# UNITED STATES PATENT AND TRADEMARK OFFICE

APPLICATION NO.	FILING DATE	FIRST NAMED INVENTOR	ATTORNEY DOCKET NO.	CONFIRMATION NO.
10/699,208	10/31/2003	Leonard Stevens	64104-00002USPT	2784
7590 07/27/2004 CROWE & DUNLEVY, P.C. 20 NORTH BROADWAY SUITE 1800 OKLAHOMA CITY, OK 73102-8273			EXAMINER MENDOZA, MICHAEL G	
			ART UNIT 3731	PAPER NUMBER

**Office Action Summary**

## **DETAILED ACTION**

**Fig. 12**

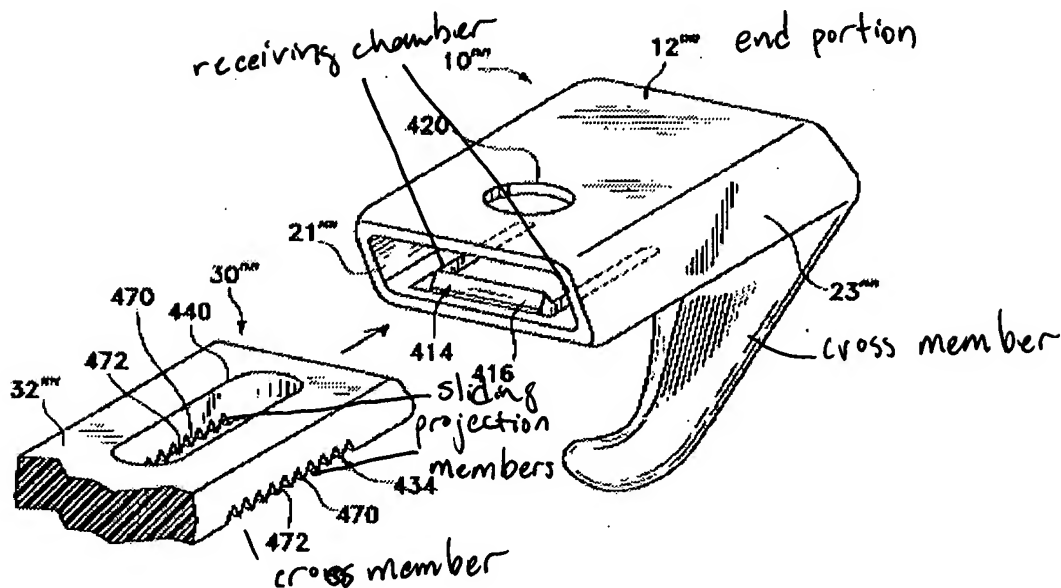
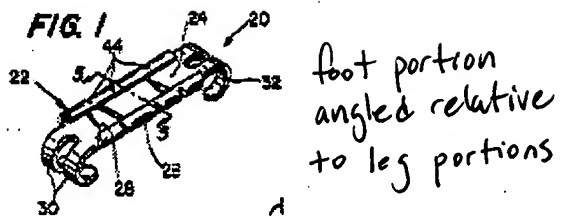
12. Regarding claims 1 and 2, Hogendijk et al. disclose in Fig. 12 the device comprising impermanently joined sliding (10''') and receiving (30''') attachment structures. Each structure has a cross member (see Fig. 12 inserted below) and an end portion (12 '''). Fig. 12 is a structurally analogous embodiment of Fig. 1 (col. 3, lines 65-67), which more clearly shows the receiving attachment structure's end portion (32) and the plurality of sternum engagement surfaces (bottom of 17 and 72, 20, 22, 40, 42). Hogendijk et al., however, disclose in Fig. 1 only one foot (20, 40) and leg (16, 36) portion on each structure and not a plurality of foot and leg portions on each structure. Crossett et al. disclose in Fig. 4 a plurality of foot (36, 38) and leg (30, 32) portions on each structure. This additional structure is simply a duplication of parts, and it is well known to add another leg or foot portion to enhance the securement of the sternum clamp to the sternum. It would have been obvious to one having ordinary skill in the art at the time of the invention to add another leg and foot portion to each structure to strengthen attachment of the device to the sternum.

13. Regarding claim 2, Hogendijk et al. disclose in Fig. 12 the receiving structure (30''') comprising a resiliently tensioned locking member with angularly disposed teeth

like structures (47) outwardly positioned at first (bottom 470) and second (top 470) ends of the locking member. Hogendijk et al. further disclose a securing aperture (440) substantially centered there between.

**Fig. 9**

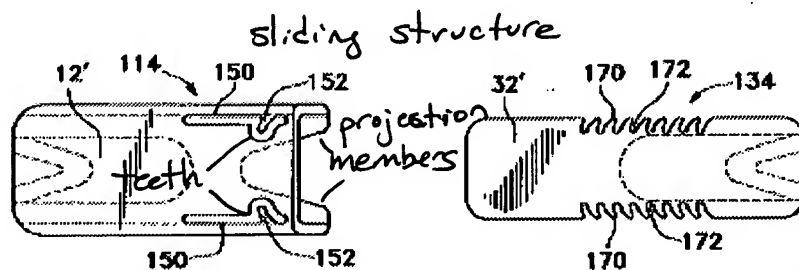
14. Regarding claims 1, 3-10, 12, and 15, Hogendijk et al. disclose in Fig. 9 the device comprising impermanently joined sliding (114) and receiving (134) attachment structures. Each structure has a cross member (12', 32') and an end portion (the left and right ends of 12', 32'). Fig. 1 of which Fig. 9 is a structurally analogous embodiment (col. 3, lines 54-56), shows the plurality of sternum engagement surfaces (bottom of 17 and 72, 20, 22, 40, 42). Hogendijk et al., however, disclose in Fig. 1 only one angled foot (20, 40, the foot is angle with respect to the leg) and leg (16, 36) portion on each structure and not a plurality of foot and leg portions on each structure. Crossett et al. disclose in Fig. 4 a plurality of foot (36, 38) and leg (30, 32) portions on each structure. This additional structure is simply a duplication of parts, and it is well known to add another leg or foot portion to enhance the securement of the sternum clamp to the sternum. It would have been obvious to one having ordinary skill in the art at the time of the invention to add another leg and foot portion to each structure to strengthen attachment of the device to the sternum.

15. Regarding claim 3, Hogendijk et al. disclose in Fig. 9 the sliding structure (114) comprising a plurality of projection members (see Fig. 9 below) with angularly disposed teeth like structures (152) inwardly positioned on each innermost surface of each projection member.

17. Regarding claim 7, Hogendijk et al. disclose in Fig. 9 the receiving attachment structure (134) comprising a securing means (170) to facilitate the operative securing of the structures to one another. The teeth (170) of one structure engage the teeth (152) of the other structure to secure the structures to one another.

22. Regarding claims 15 and 17, Hogendijk et al. disclose in Fig. 9 the device wherein the securing means (170) may be removed to facilitate immediate device disengagement.
